REPLACEMENT OF EXTERIOR STAIR
24 WOLCOTT HILL ROAD
WETHERSFIELD, CONNECTICUT
PROJECT: BI- 2B- 351

BID OPENING	1:00 P.M.	7-23-2013
ADDENDUM NUMBER 1	7-18-2013	7-18-2013

SK-A1

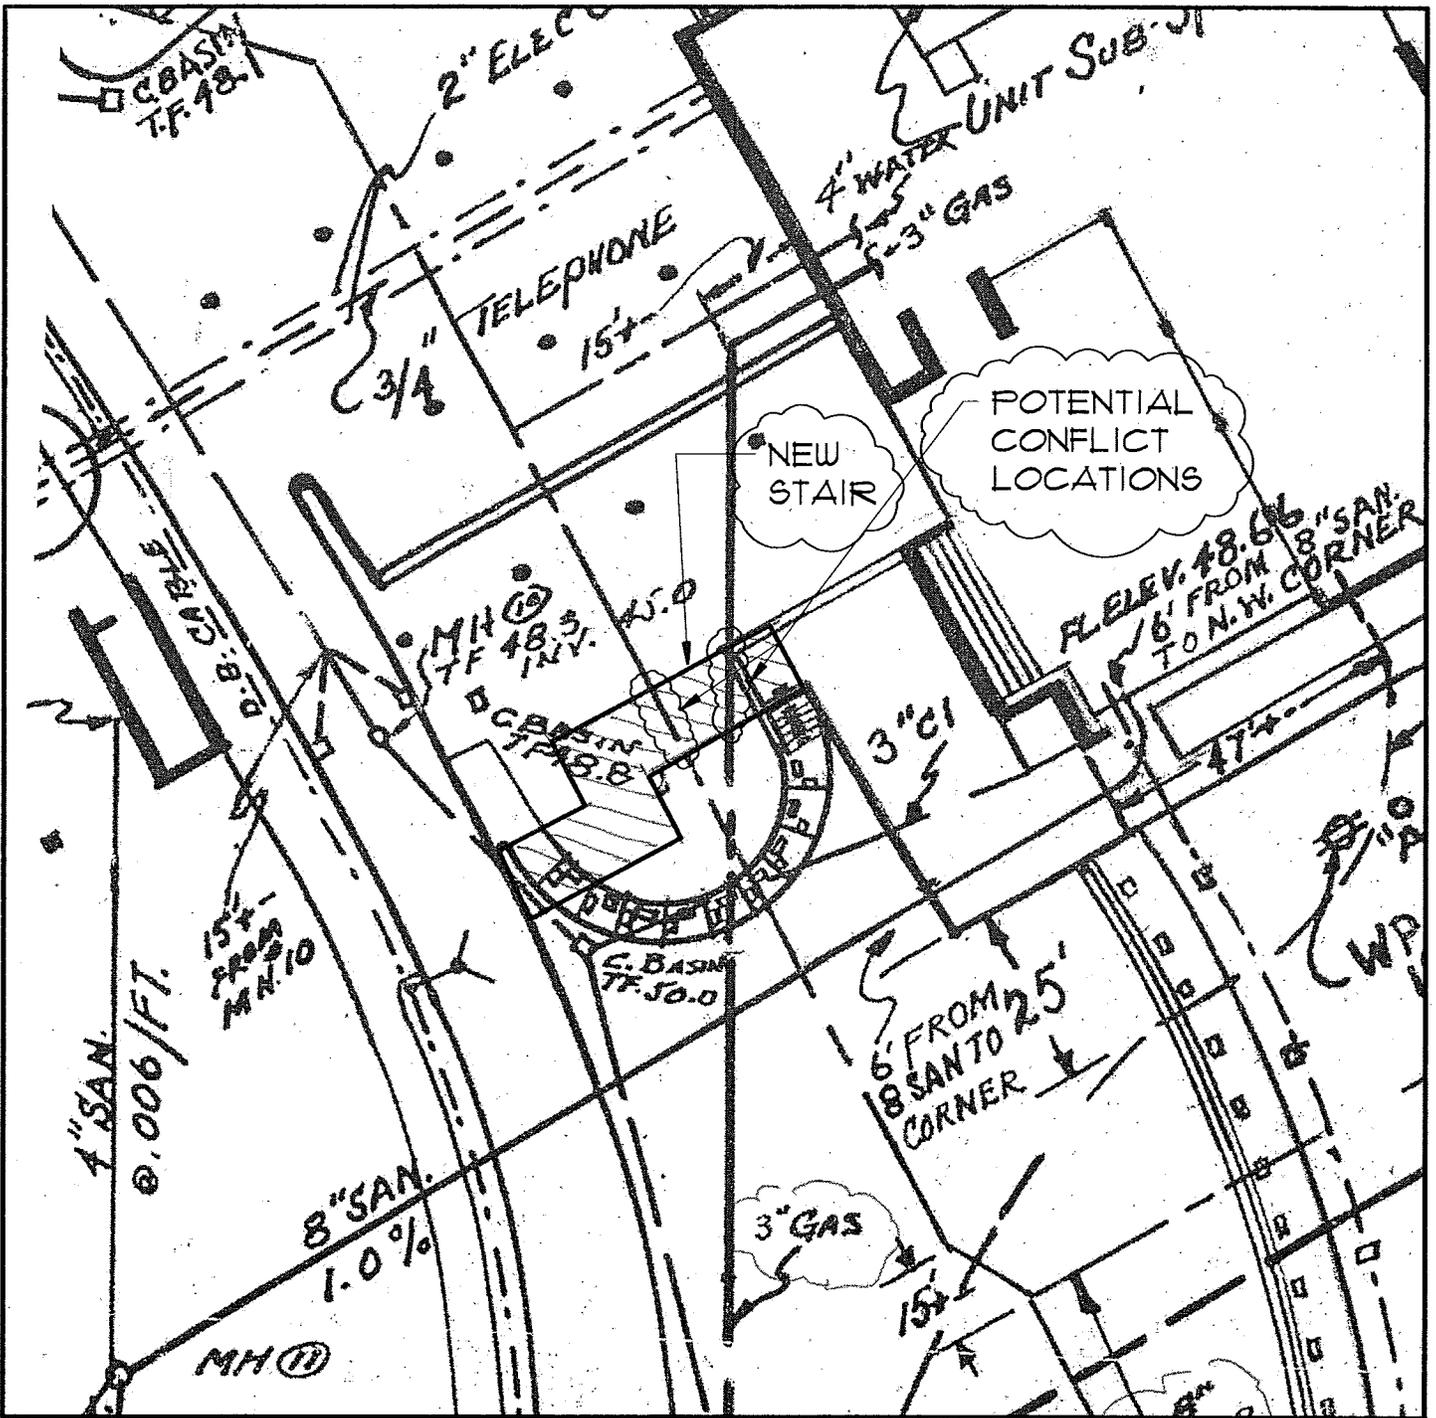
Site Utilities Information is provided in attached SKA-1.
